**North Liberty**  
**Planning**  
**Commission**  
Meeting Information

To: North Liberty Planning Commission  
From: Dean Wheatley, Planning Director  
Subject: Site Plan Approval Request  
(Lot 10 Liberty Centre Part One)

This request of Penn Street Group LLC to approve a commercial site plan located on Community Drive west of Ranshaw Way/965.

SITE LAYOUT AND  
DIMENSION PLAN

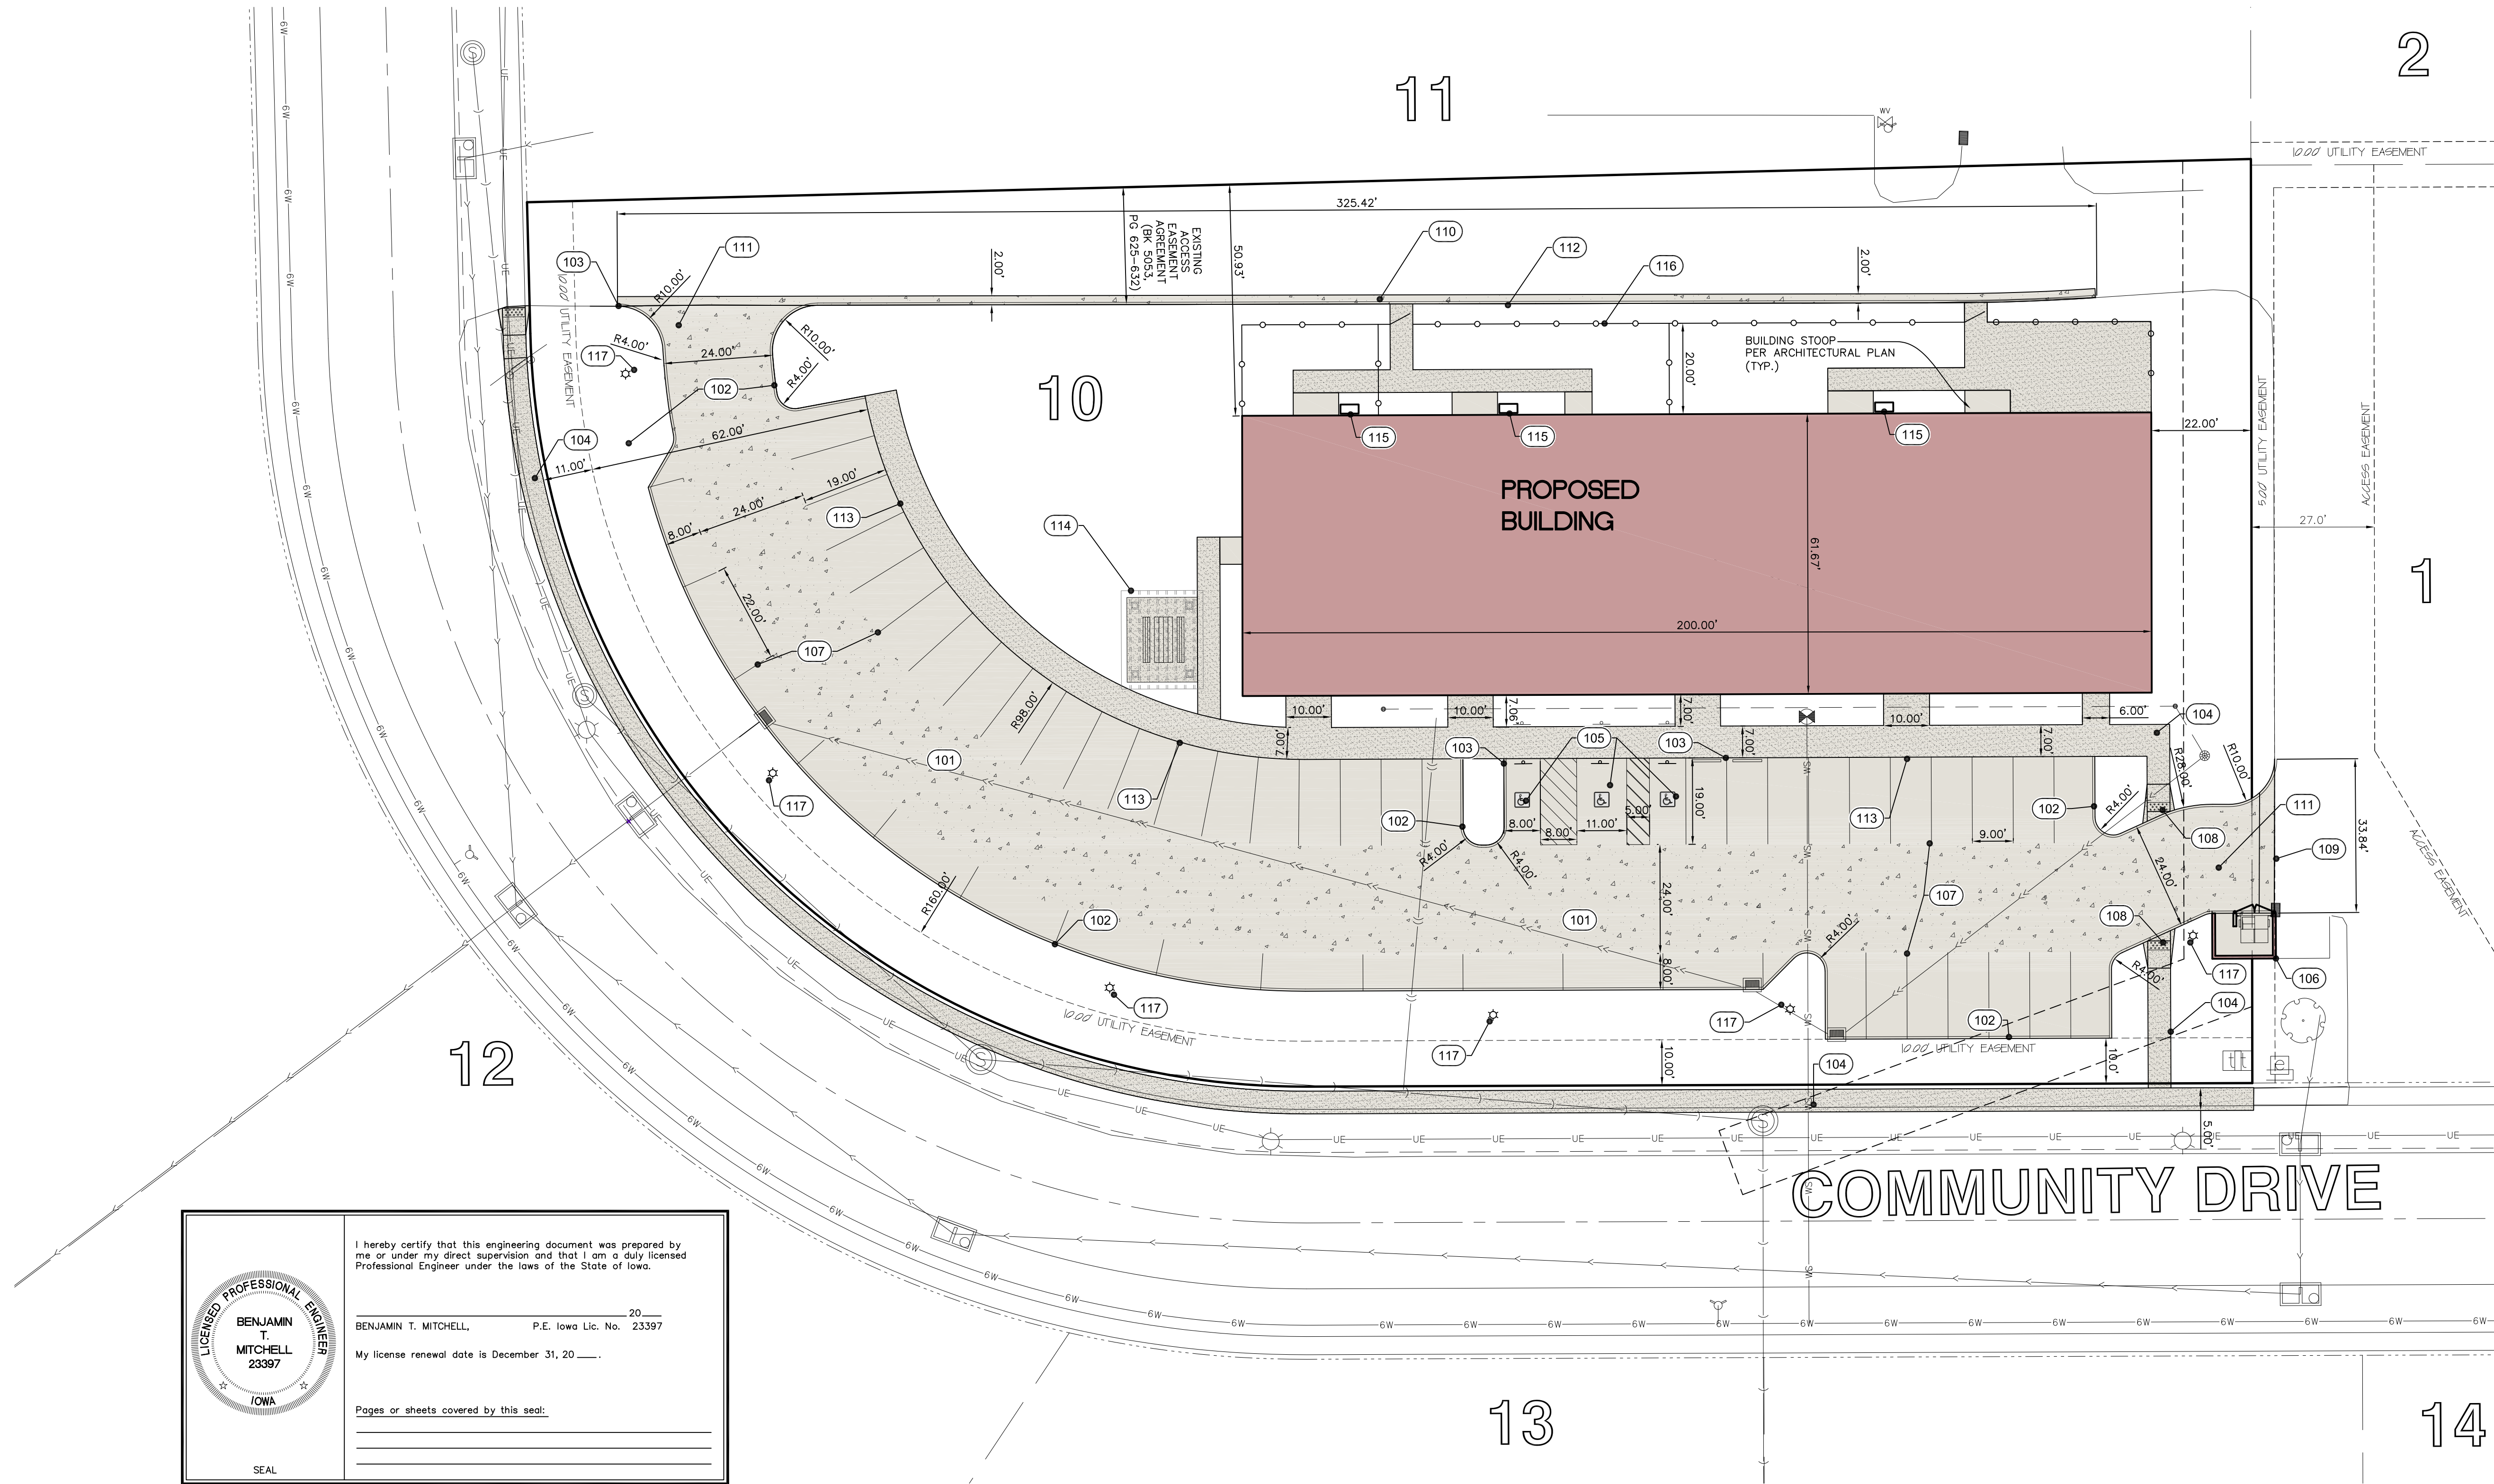
The site layout is straightforward, with ample parking (21 required, 54 provided) and good vehicular circulation. Landscape planning and pedestrian accommodations are complete. The entire frontage is lined with parking, but is set back about 20 feet from the sidewalk, with landscaping in that 20 foot area.

Sheet Title:  
EXTERIOR  
ELEVATIONS

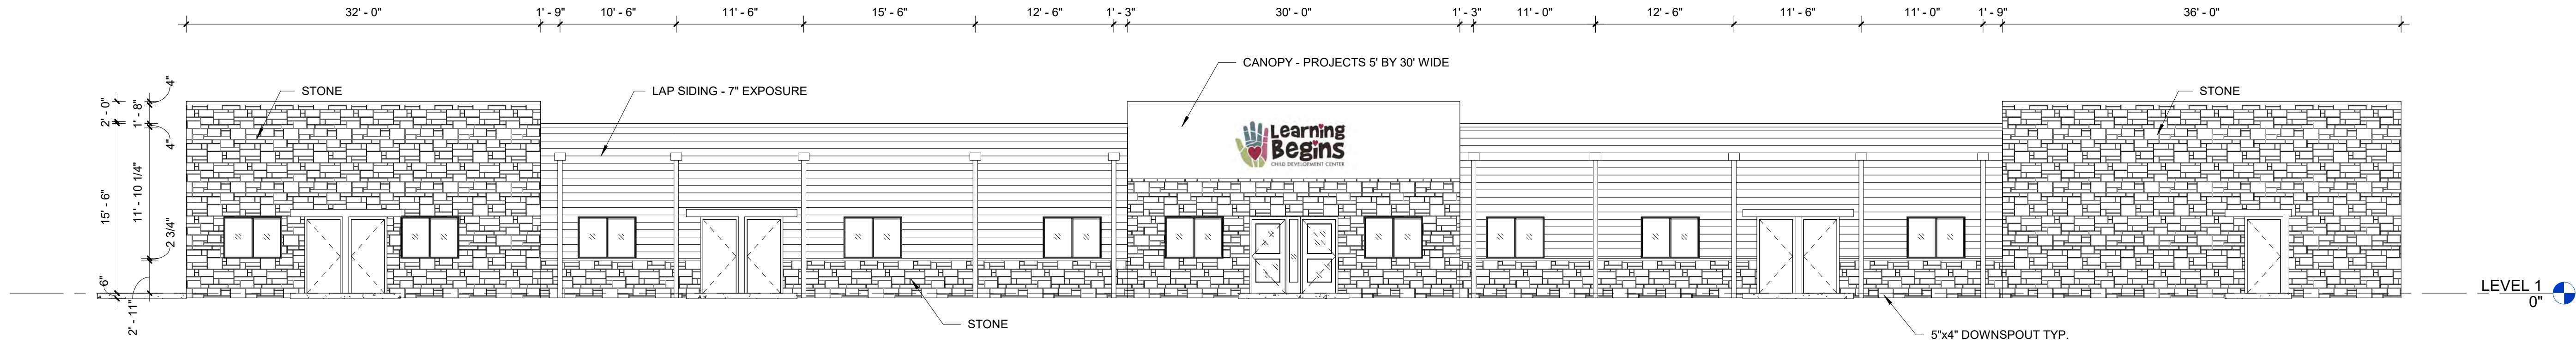
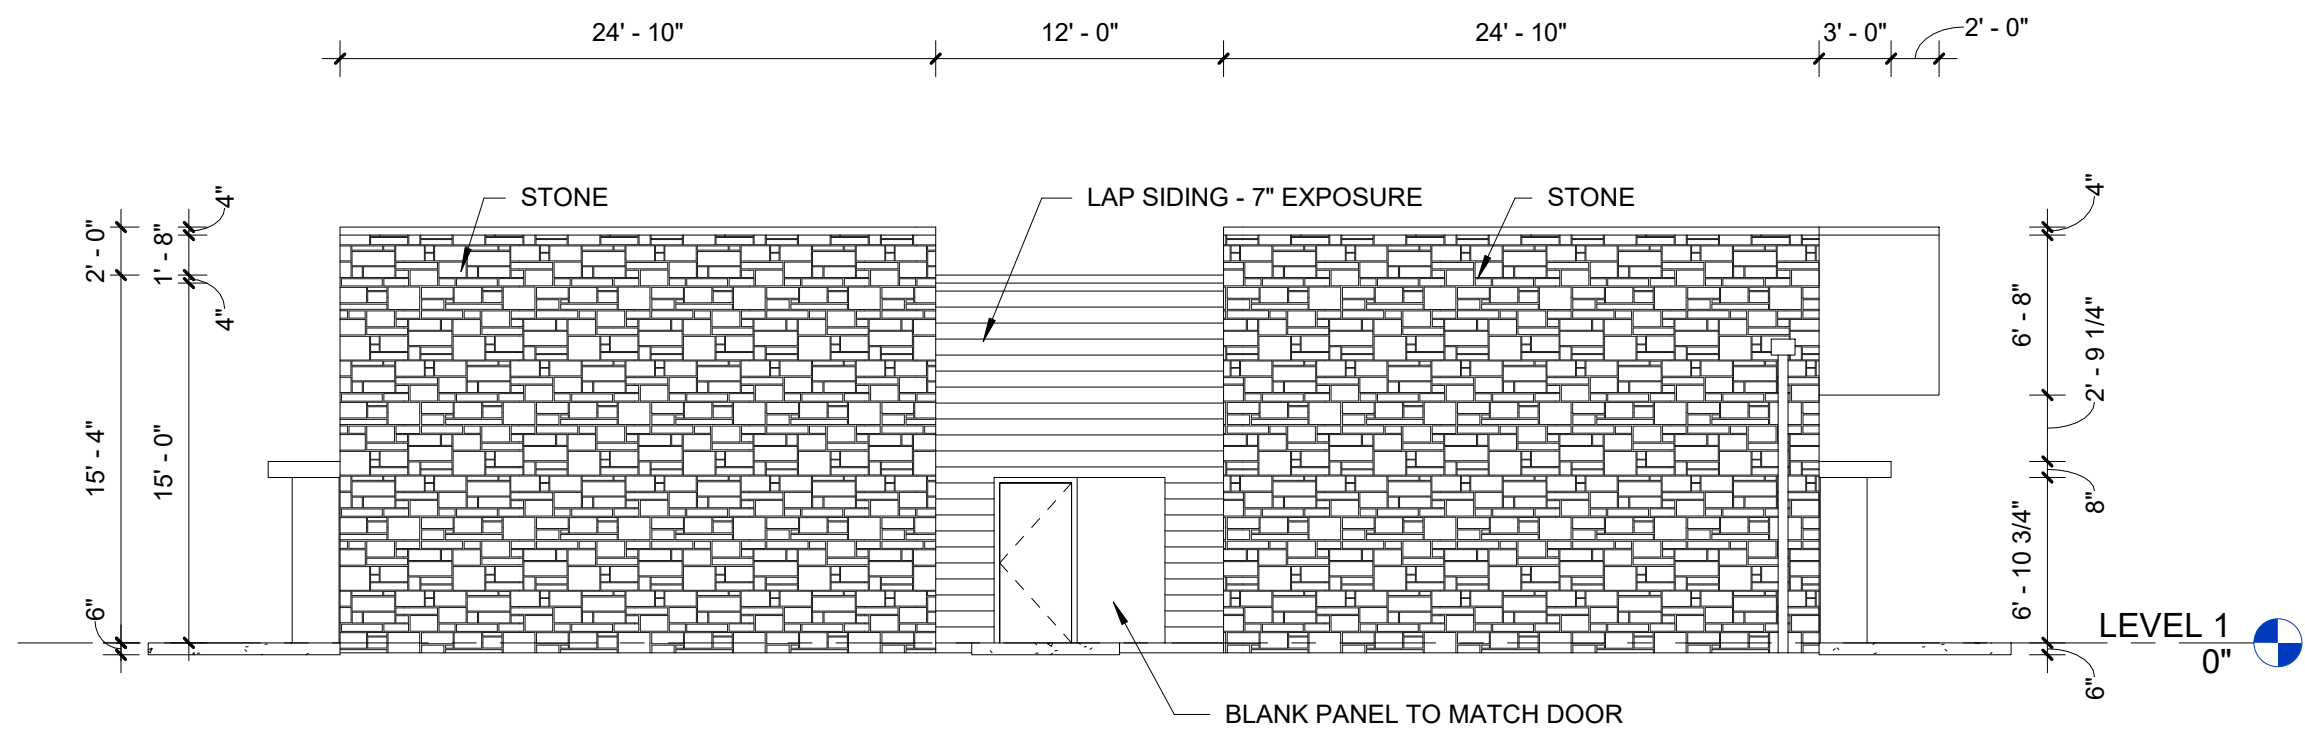
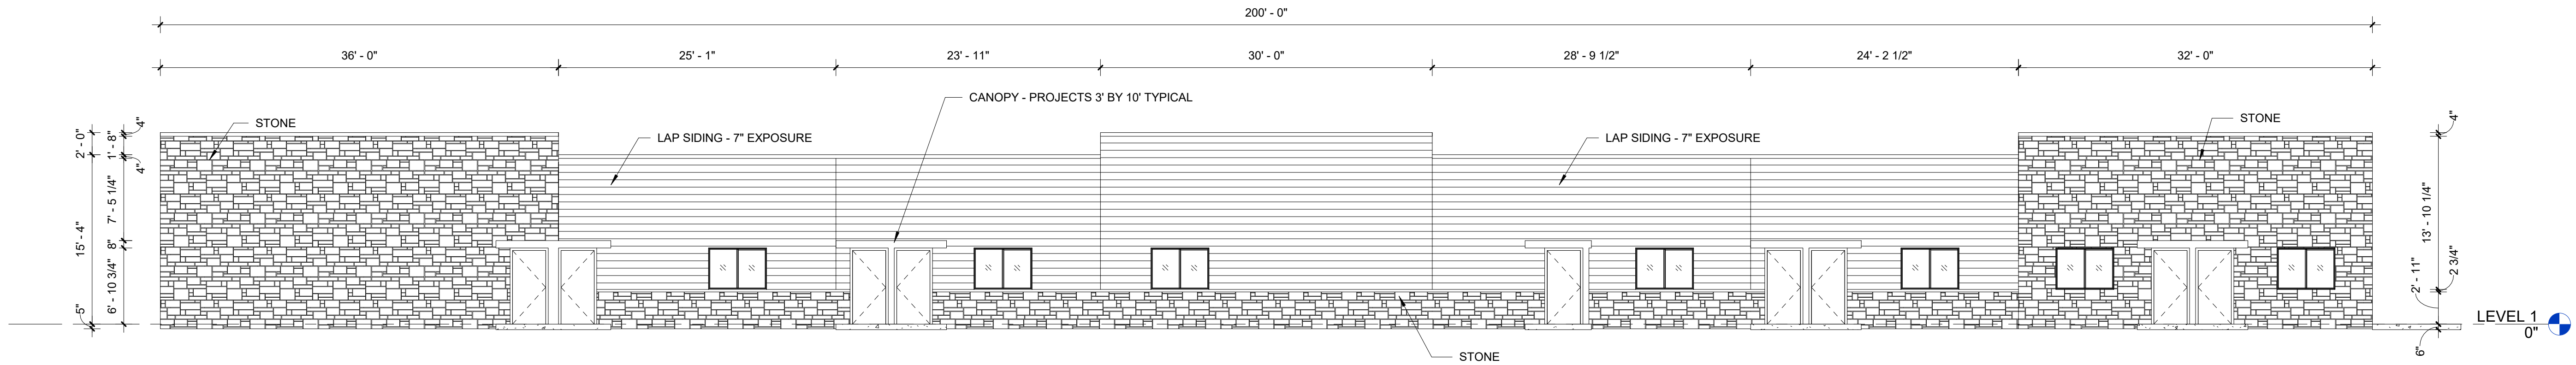
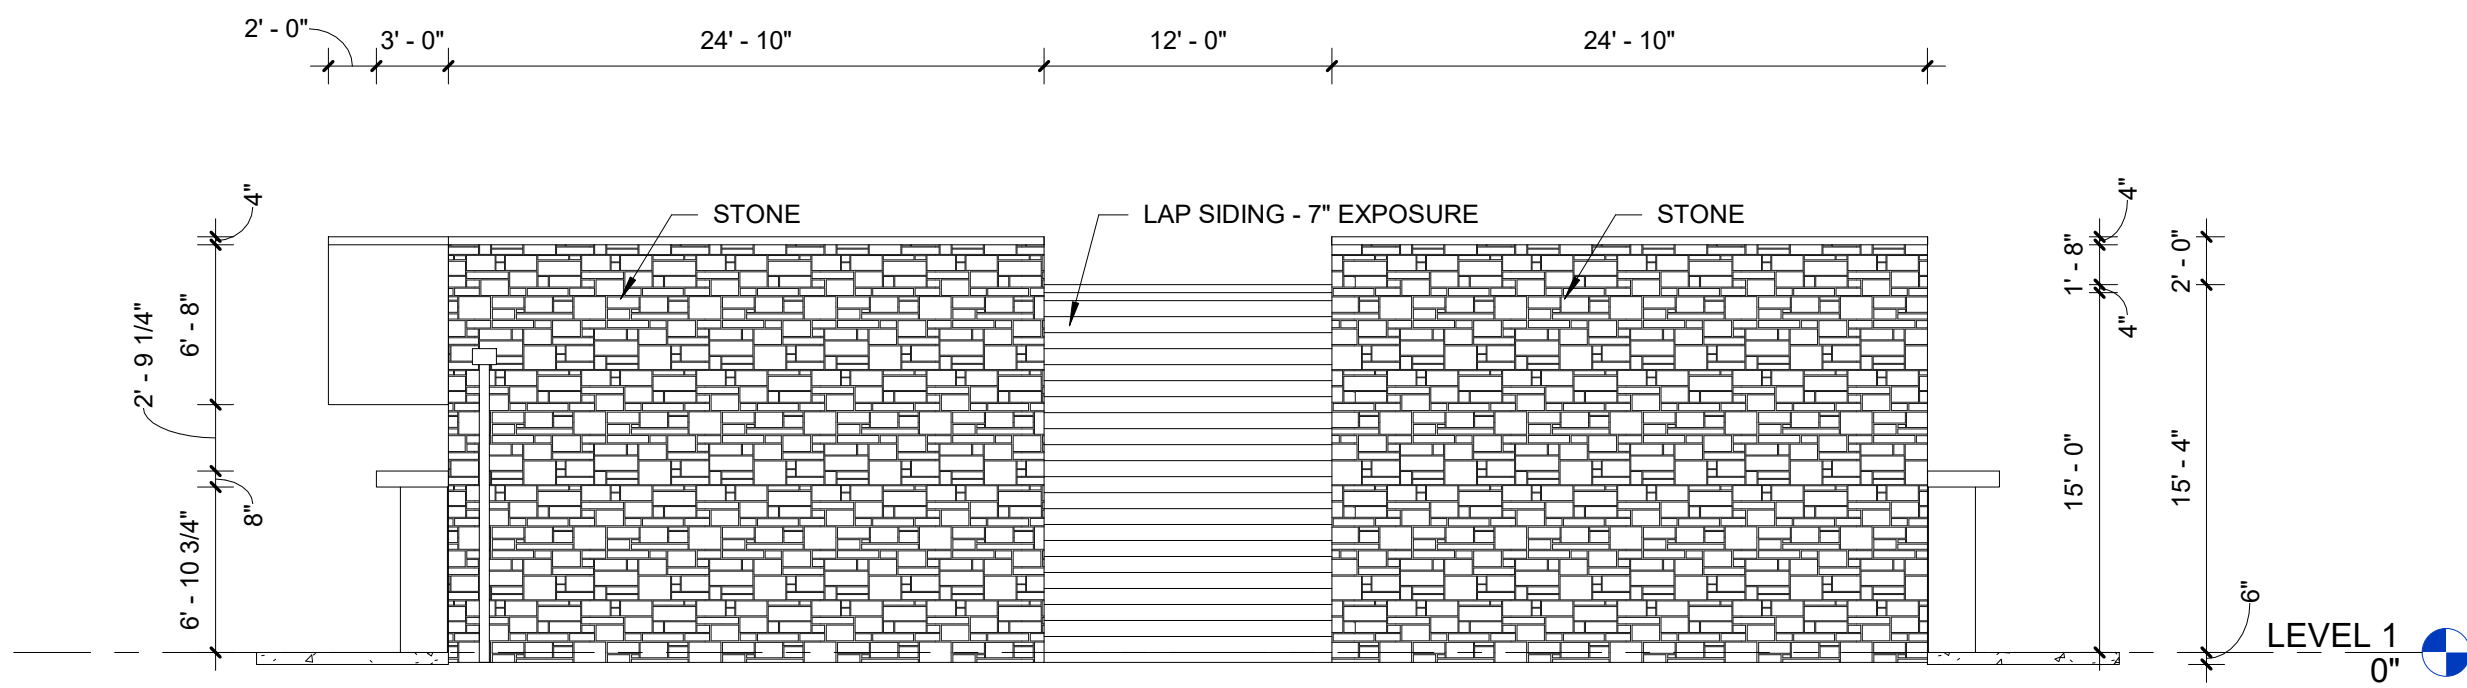
The building is a clean modern design that meets general design standards. HVAC equipment is on the roof, screened behind parapet walls.
